Amphenol Taiwan Corporation

Product Change Notification

Part Numbers Concerned :	GSB4111312HR;GSB4111313HR	Originator:	Debby Hung
Customer P/N:		Issue Date:	2021/07/13
Product Description:	USB 3.1 CONNECTOR STANDARD A R/A DIP TYPE R/A DIP TYPE	PCN NO:	1210-21001170
Distribution:

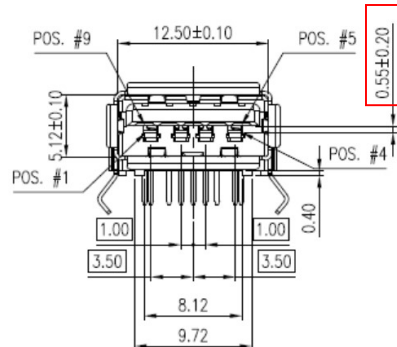
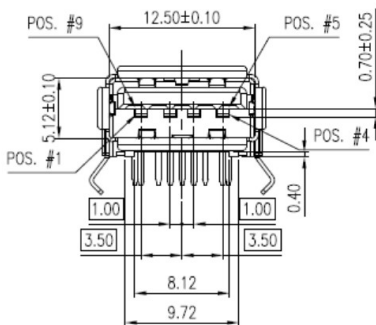
Old version part:

1. P/N: GSB41113XXHR: REV:B -->

New version part:

New P/N: GSB4111XXHR:REV: C

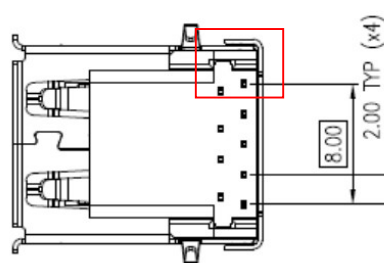
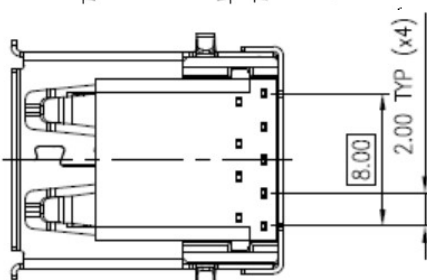
2. Contact high reduces lower to meet required 10K durability.

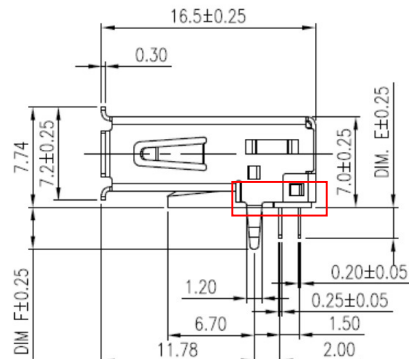
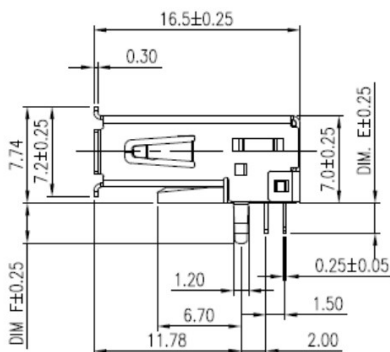
3. The gap increasing between shell and PCB is to avoid short circuit and raise safety factor, and stand-off area change of housing is to avoid soldering overlapping.

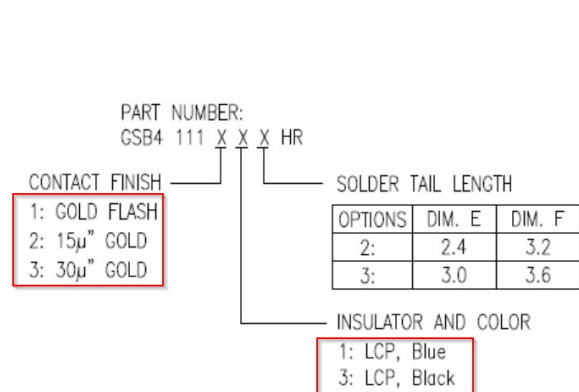
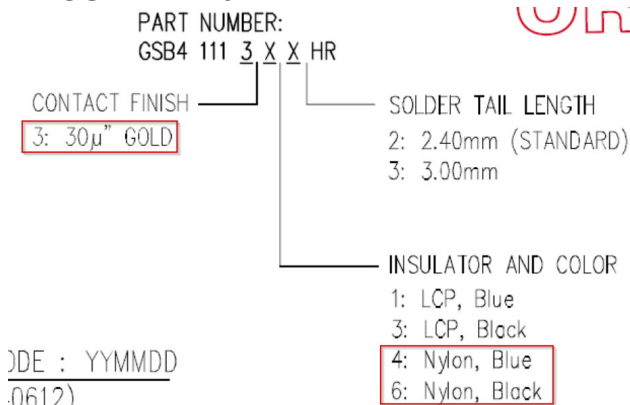
4. Decreasing the width of terminal to avoid damage while connector mounting on PCB
